Access Compliance Report

Public Rights-of-Way

(Pedestrian Signals)

Intersection ID: N/A	Main Street:	Cross Street: N/A	Location: N/A
ADA ID: 9A12C3F5CA84	Signal Type: One Push Button-Non APS	Overall Compliance: No	Severity Score: BTN 1: N/A BTN 2: N/A No BTN: N/A
Codes/Mitigation Info/Possible Solution		Field Measurements/Component Compliance

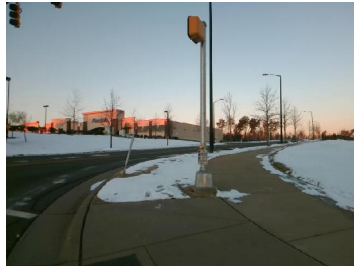
PROW/ADA: TMUTCD 4e.08, R404.2, R404.3, R406.2, R404.7.2

N/A	B 1 Clear Xing Direction?	Yes	N/A	B 2 Clear Xing Direction?	N/A
	B 1 Crossing Direction	To S		B 2 Crossing Direction	N/A
No	B 1 DistanceTo XWalk (in)	70.0	N/A	B 2 DistanceTo XWalk (in)	N/A
No	B 1 DistanceTo Curb (in)	79.0	N/A	B 2 DistanceTo Curb (in)	N/A
Yes	B 1 Diameter (in)	2.0	N/A	B 2 Diameter (in)	N/A

Possible Solutions: Replace Signal Push Button With APS Button on New Post. Remove & Relocate Sign.
